REMARKS/ARGUMENTS

Appl. No. 10/698,198
Amd. Dated January 20, 2005
Reply to Office Action of October 6, 2004

Amendments to the Drawings:

Fig. /
PRIOR ART

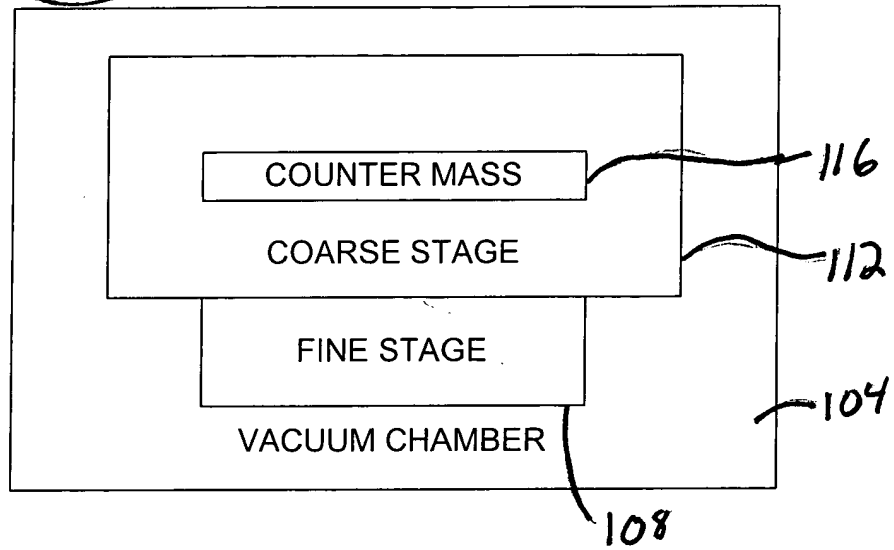
The drawings have been objected to by the Examiner. In response to the Examiner's objection to Figure 1, Figure 1 has been amended to include a --Prior Art-- legend. Drawings sheets which show the amendment made to Figure 1, as well as a replacement sheet for Figure 1, are being submitted herewith. As such, it is believed that the Examiner's objection to Figure 1 has been overcome.

The attached sheet of drawings includes changes to Fig. 1. This sheet, which includes Fig. 1, replaces the original sheet including Fig. 1.
